**Re: Polk Well #4 (PR#38-2019)
City of Independence (PWS ID#41-00399)
Site Plan Approval**

Project Description – Polk Well #4

Figure 1. 50-, 100-, 200-, and 500-ft radii shown around proposed well location

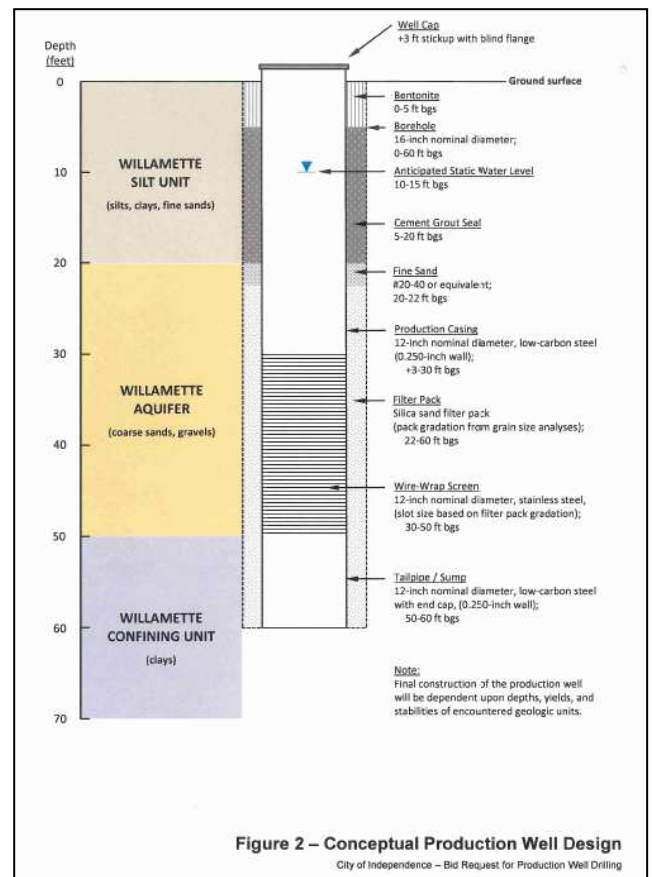
The project includes drilling a new well (Polk Well #4) to increase the redundancy, resiliency, and overall capacity of the City of Independence water system. The well is planned for construction in the summer of 2019 within the City’s existing Polk Wellfield adjacent to the Willamette River on Tax Lot 2009 (T8S, R4W, Section 21), approximately 268-ft west of the Willamette River as shown in Figure 1. The proposed site allows for a 100-ft radius of control and setback from roadways and other hazards.
